Level 1 Floorplan

Modifications

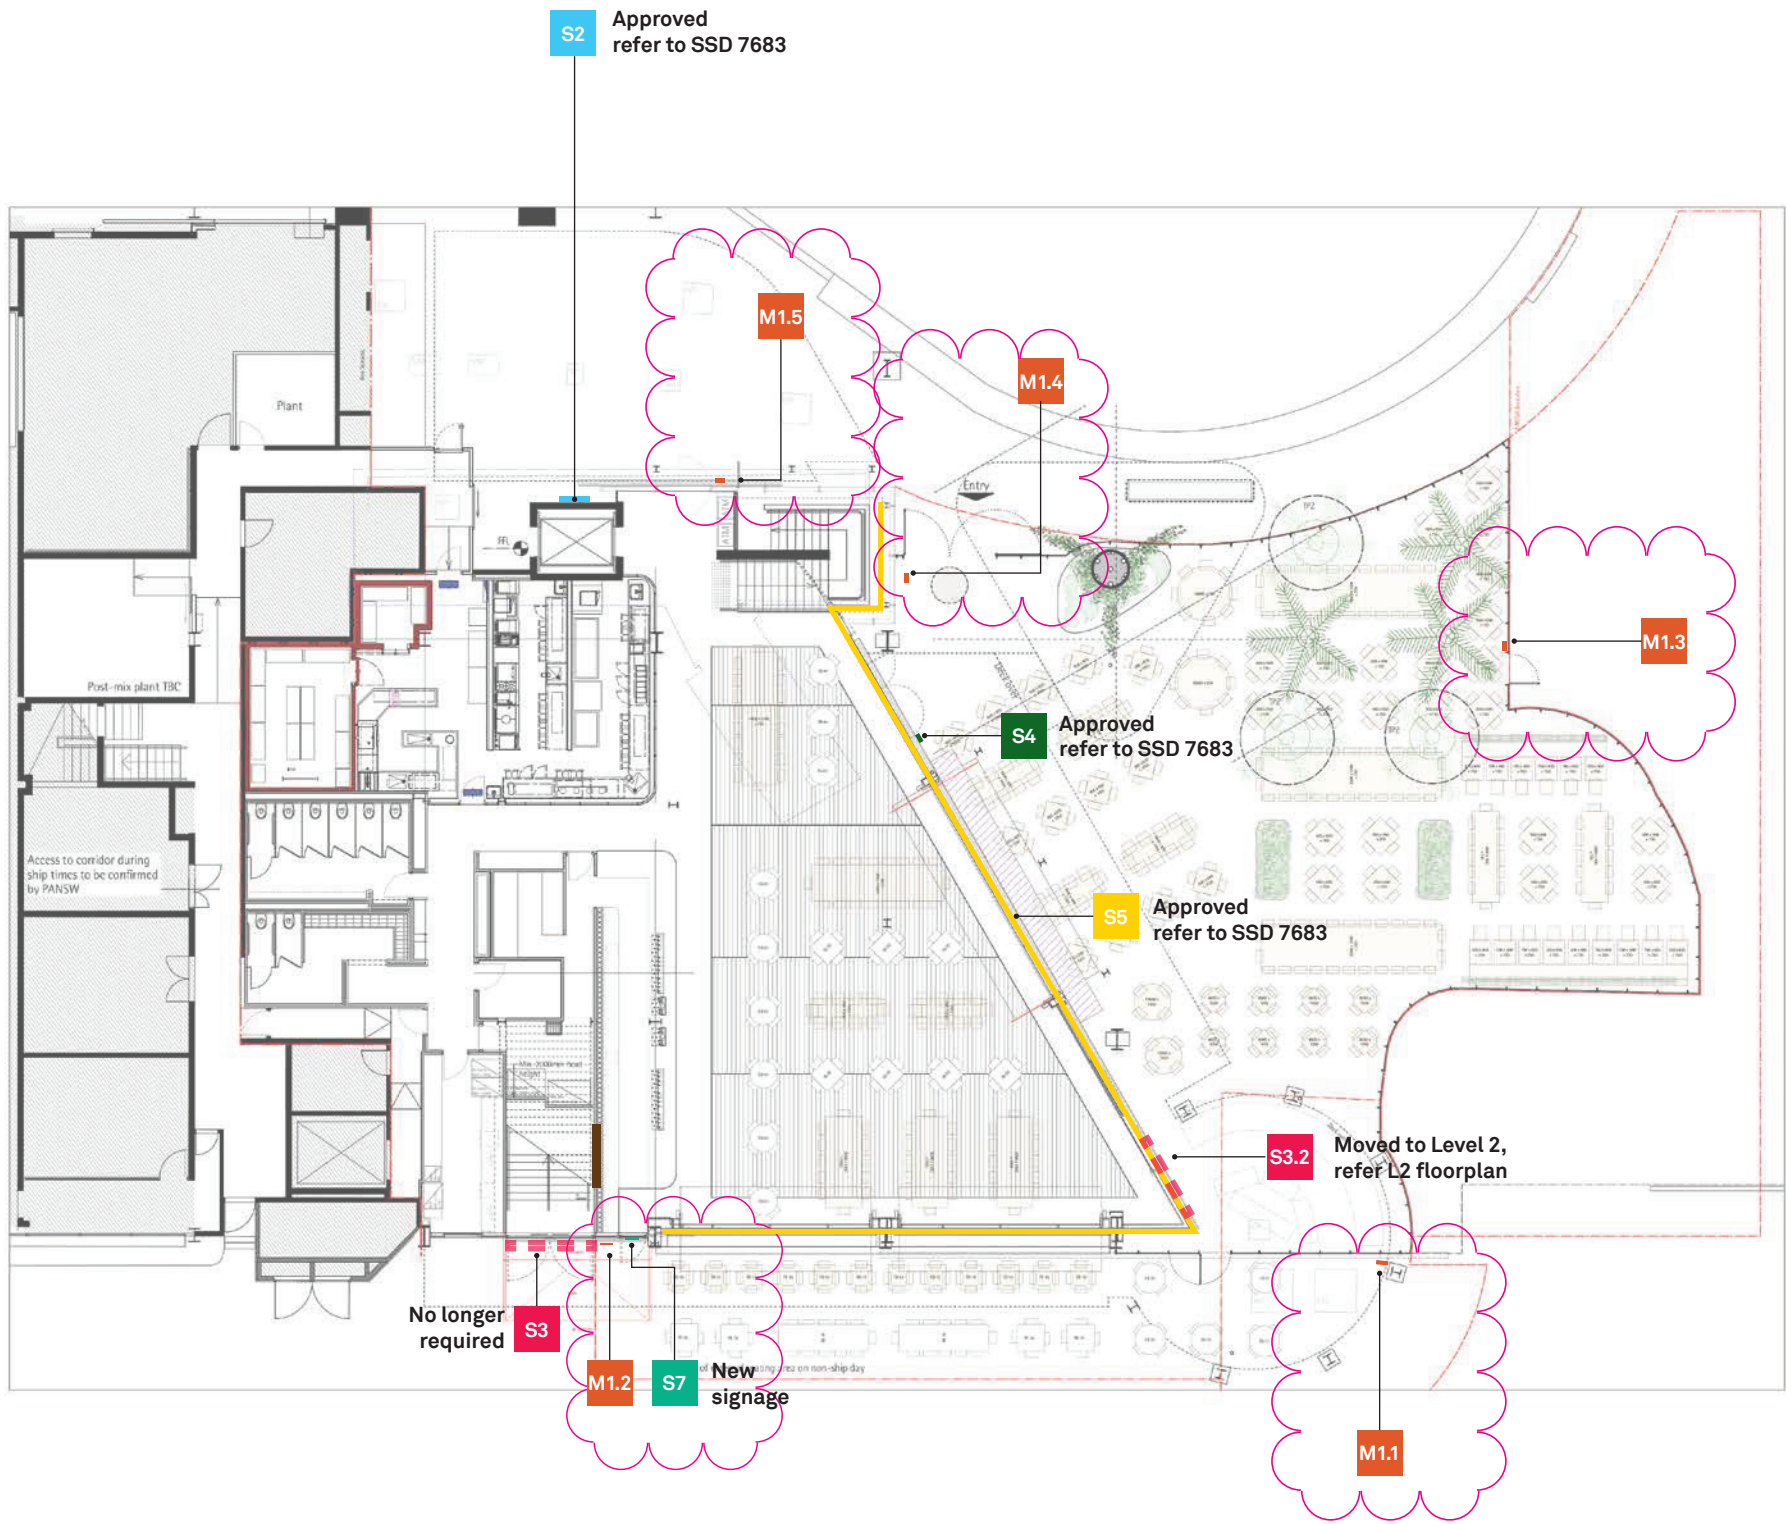
- S7** The Squire's Landing logo window vinyl
Non-illuminated – ground floor external door.
New vinyl signage – as this door is being used by customers as an entry point
 - S3.2** James Squire Signature + Cross Shovels identification
moved to Level 2, refer L2 floorplan
 - M1.1 to M1.5** Menu Stand
Freestanding menu stand with illuminated logo and menu
- Modification**
Five new menu stands see construction below

Level 2 Floorplan

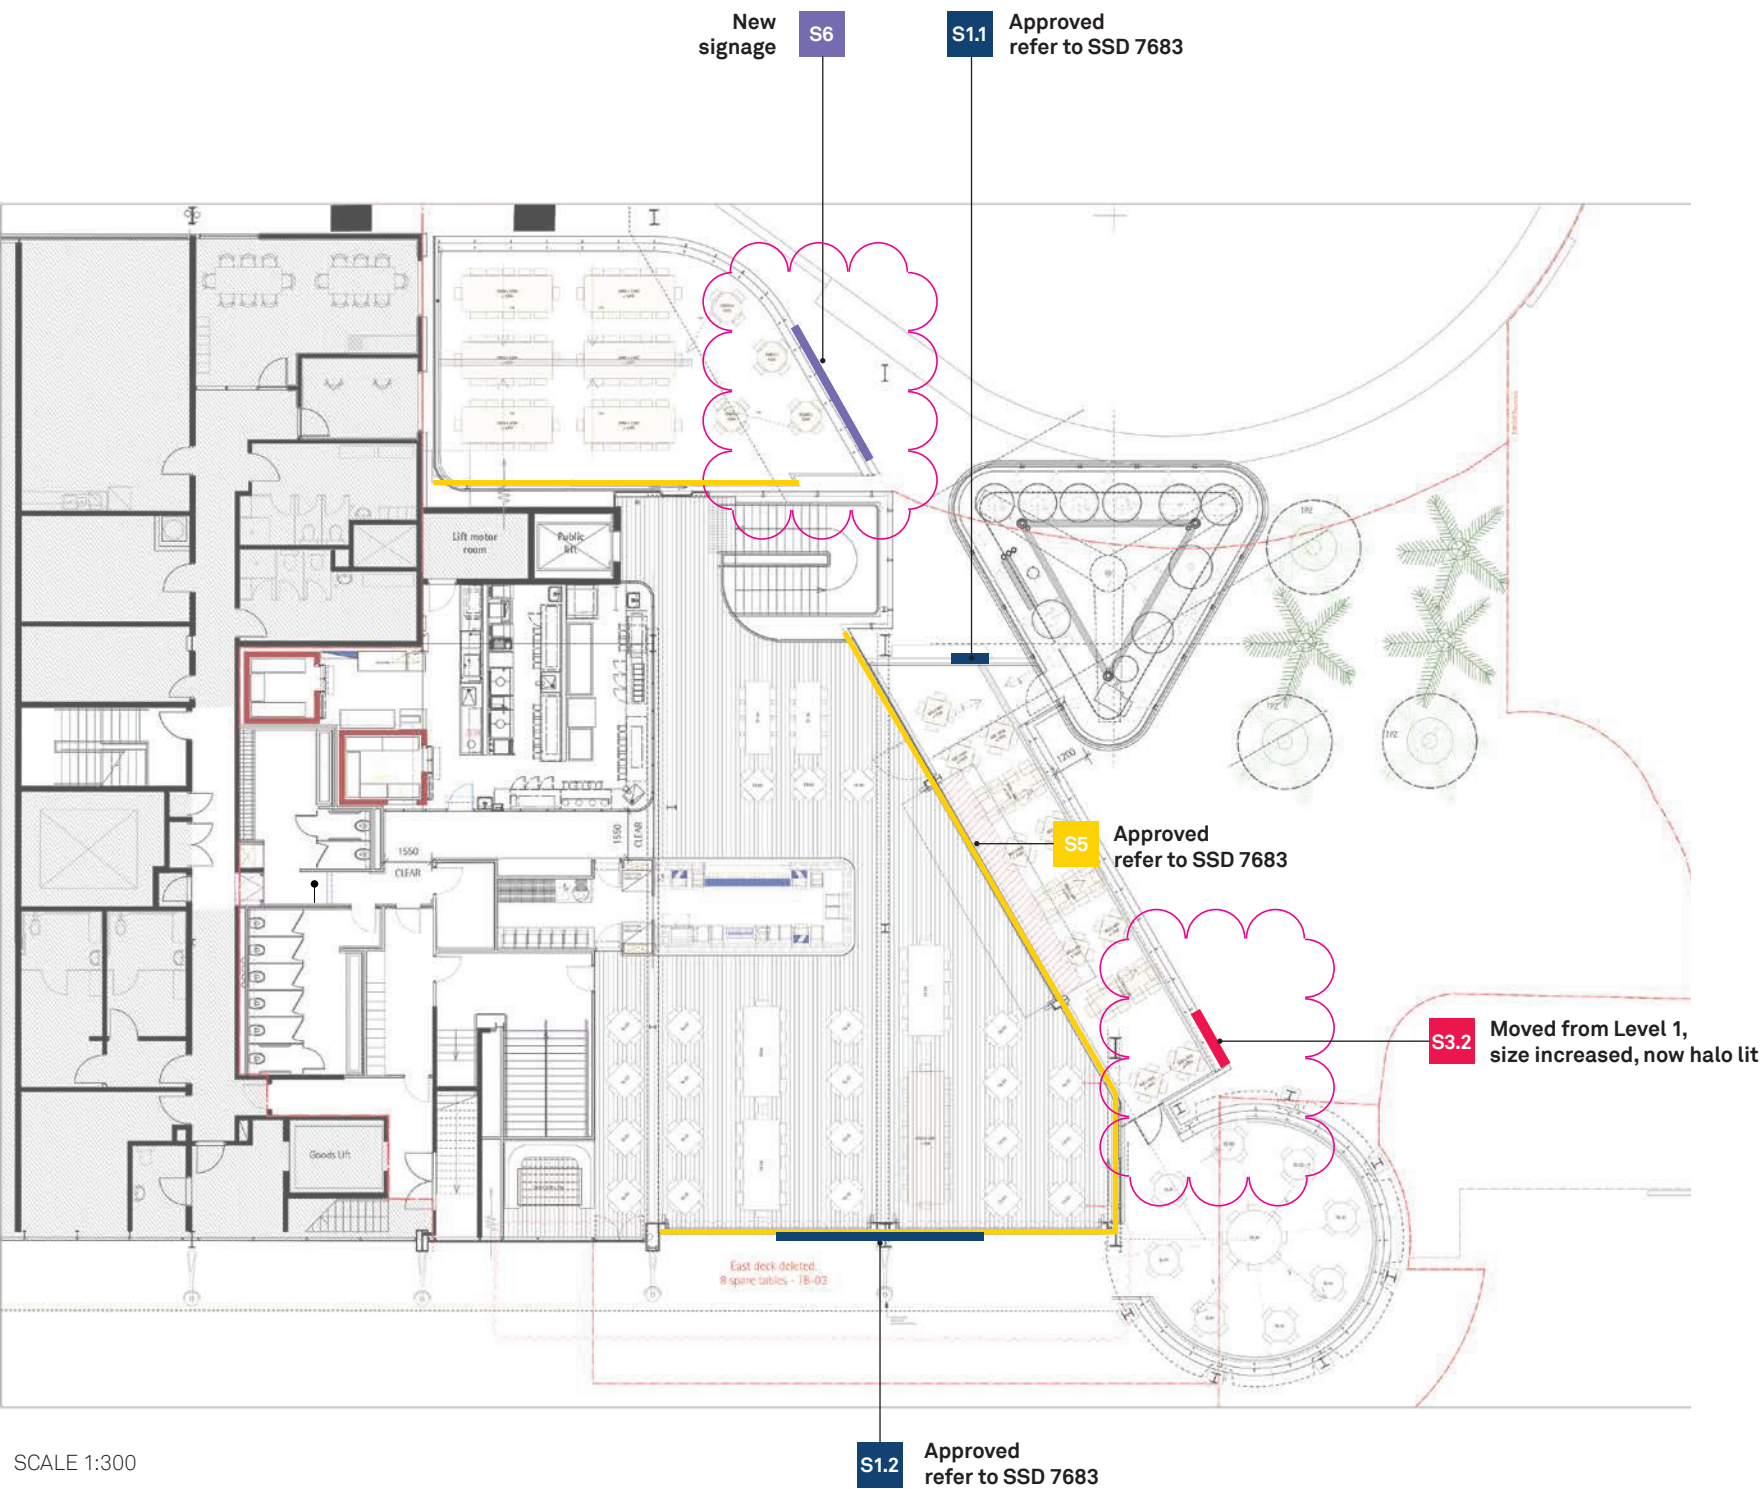
- S3.2 James Squire Signature + Cross Shovels identification
S3.2: relocation from ground floor low level building spandrel to Level 2 awning beam. Size increases from 1285 x 220mm to 2440x380mm. Sign now halo lit.
- S6 The Squire's Landing identification
New sign Level 2 balcony. Sign is illuminated.

01 East Elevation
Scale 1:200

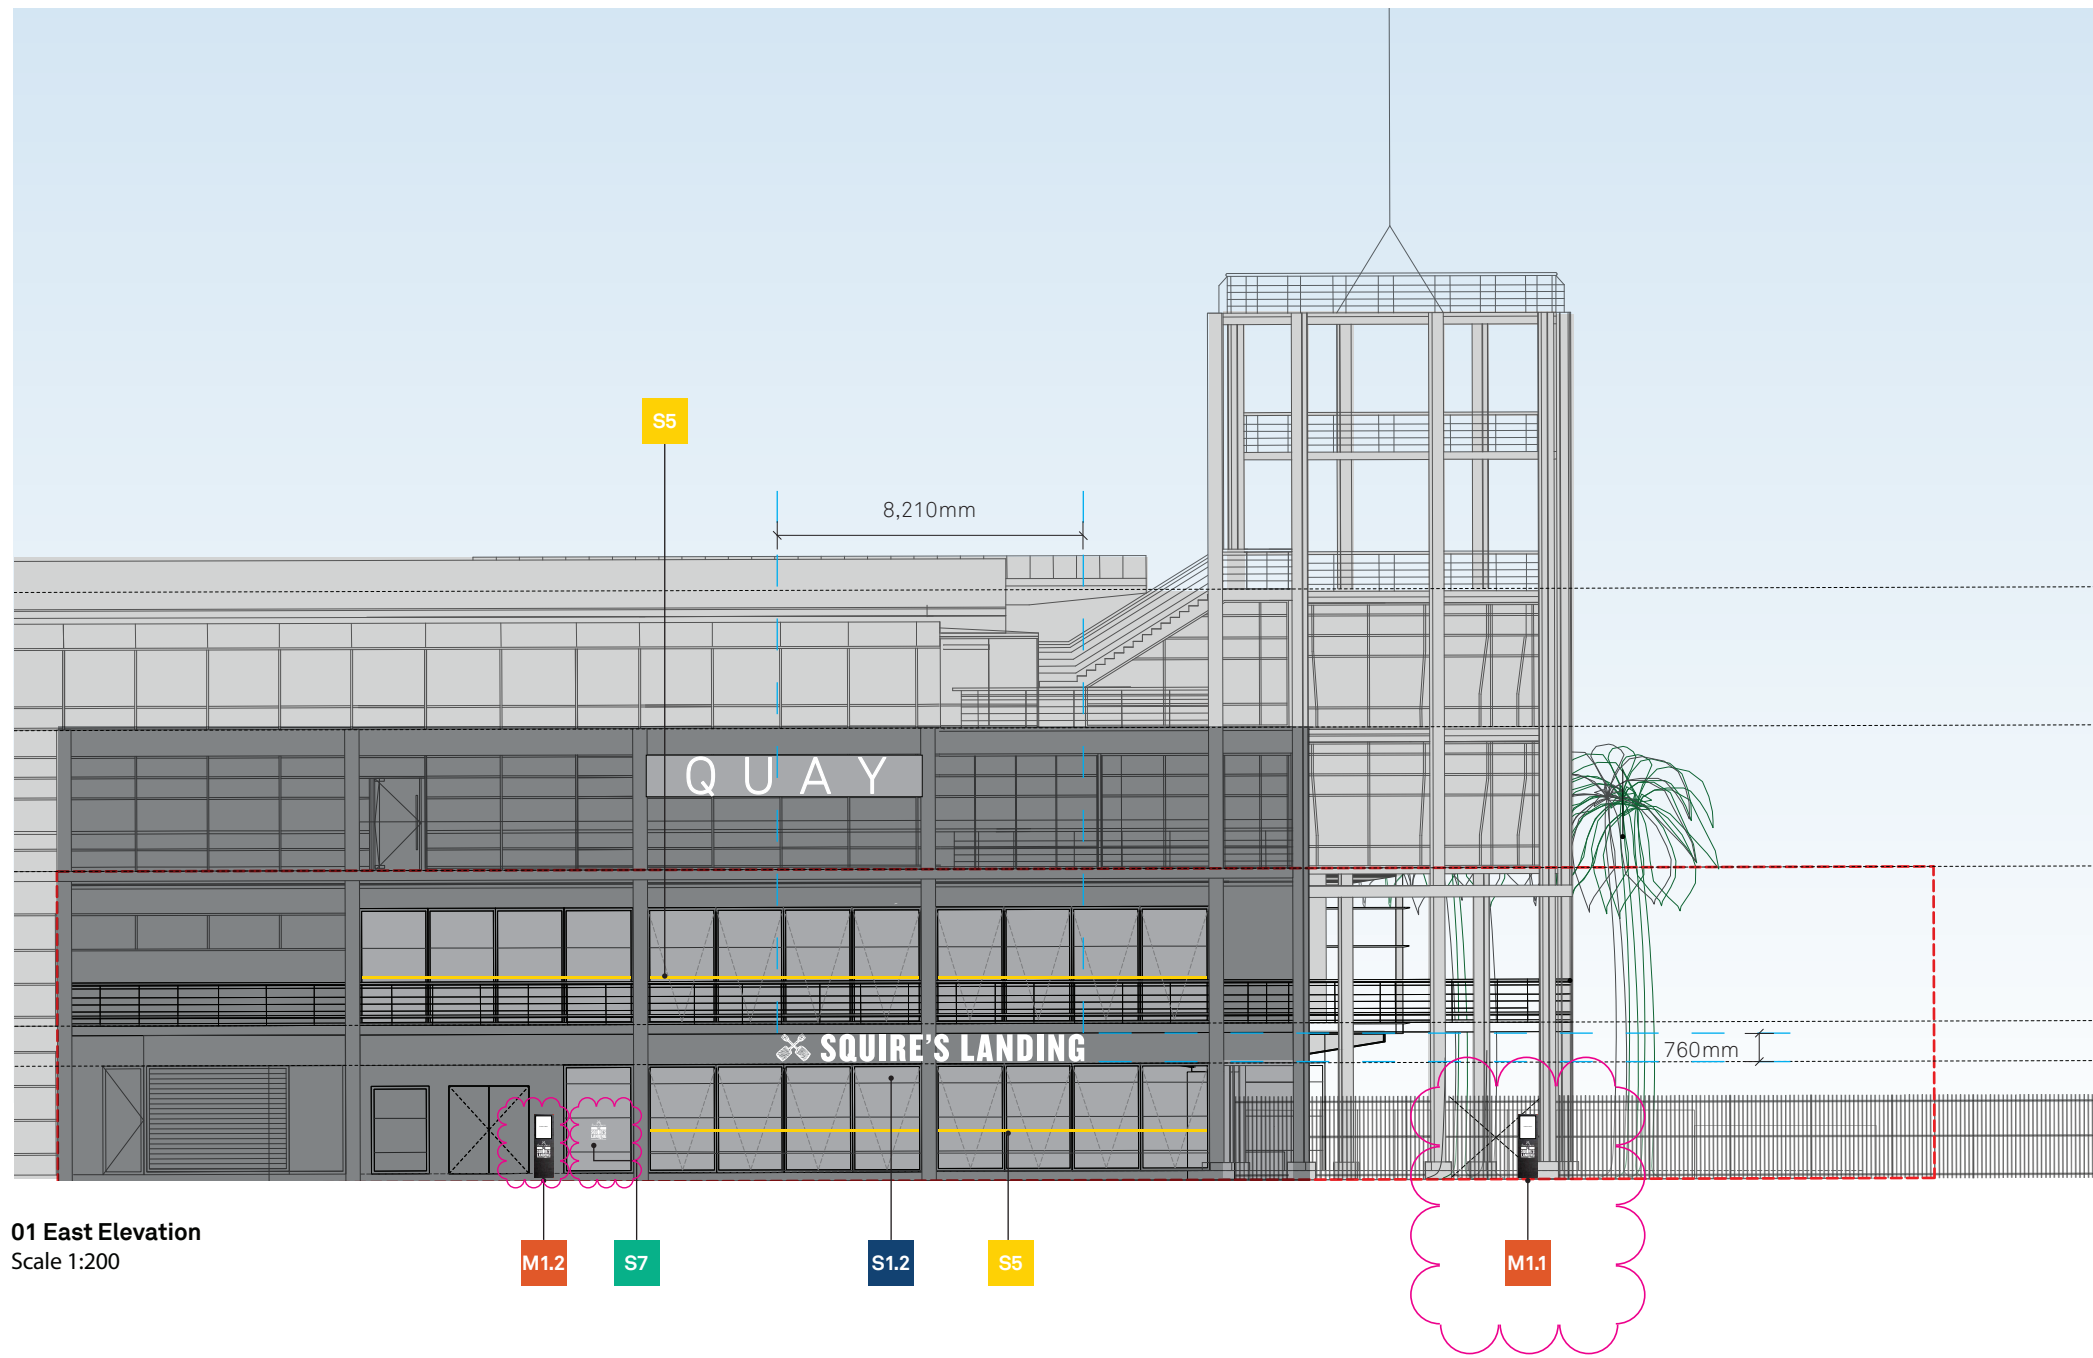
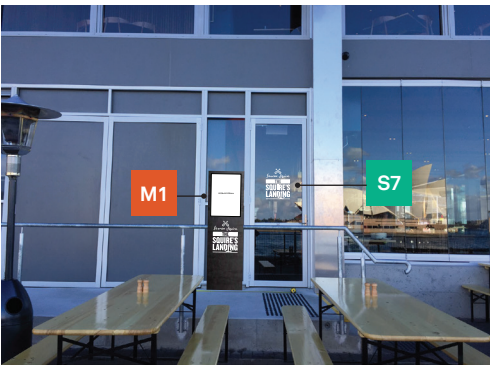
- S7** **The Squire's Landing logo window vinyl**
Non-illuminated – ground floor external door.
New vinyl signage – as this door is being used by customers
a an entry point
-  **M1** **Menu Stand**
Freestanding menu stand with illuminated logo and menu
